Attachment 1 - PLN22/0325 - Originally advertised plans

2-8 Brighton Street Richmond RFI Response

Prepared for
City of Yarra

Attachment 2 - PLN22/0325 - Original Council referral comments

Figure 1: Little Lesney Street entrance to Residential Bike Store (not to scale).

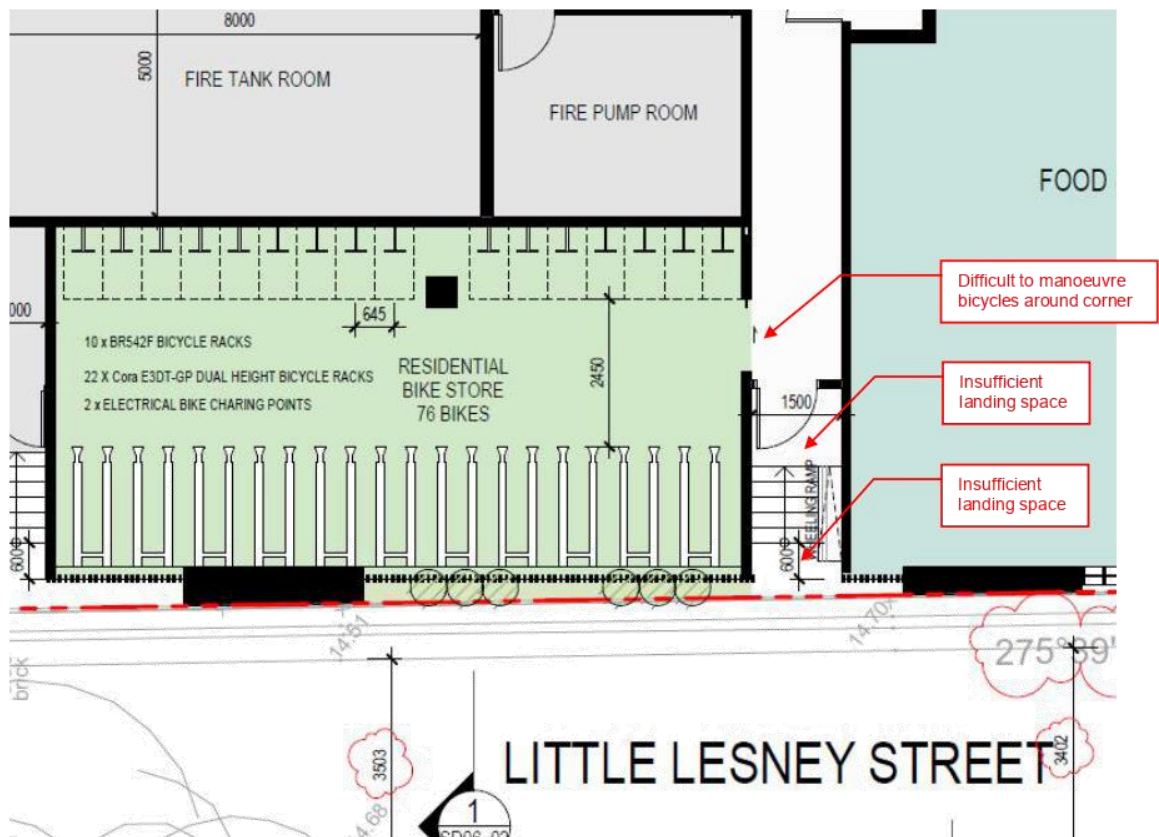
It is noted that the Residential Bike Store is accessed from Little Lesney Street via a staircase with bicycle wheeling ramp (refer **Figure 1** below). Whilst the proposed wheeling ramp is not ideal, it could be accepted if alternative solutions aren't possible, however it is to be designed to comply with AS2890.3.
